## Change Order, Construction Manager as Adviser Edition

HCS Child Nutrition  
Elizabethtown KY

Change Order Number: 016  
Date: March 3, 2026

<b>PROJECT NAME :</b>	HCS Child Nutrition
<b>OWNER JOB # :</b>	
<b>WEHR JOB # :</b>	24-069
<b>CHANGE ORDER TITLE :</b>	RFI 057 Evaporator Coil Changes
<b>CHANGE ORDER # :</b>	16

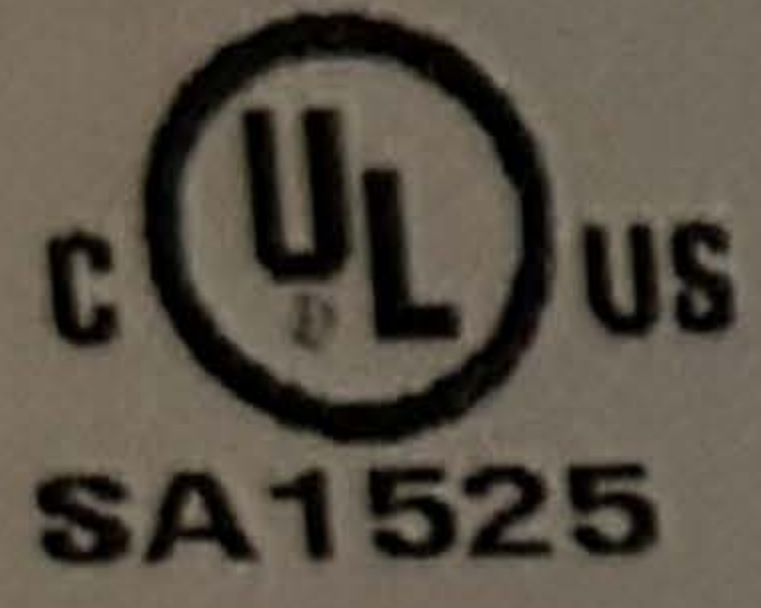
1. Refer to Drawing Sheet E-201: See attached photo taken of the nameplate on one of the freezer evaporator coil units. It appears that these (4) units will require increased circuit sizes to include breaker and disconnect changes. Please review and confirm that the following changes to the design are required:
  - A) Change the (4) 30A/3P breakers in panel OS1 that are associated with these units to 45A/3P breakers.
  - B) Change the (4) 30A/3P NF disconnects that are associated with these units to 60A/3P NF disconnects.
  - C) Confirm whether or not #8 THHN Copper conductors to be sufficient to feed each of these units based on the new loads?

I concur with the changes detailed in the attached document. Yes, #8 wire will still be sufficient to carry the load.
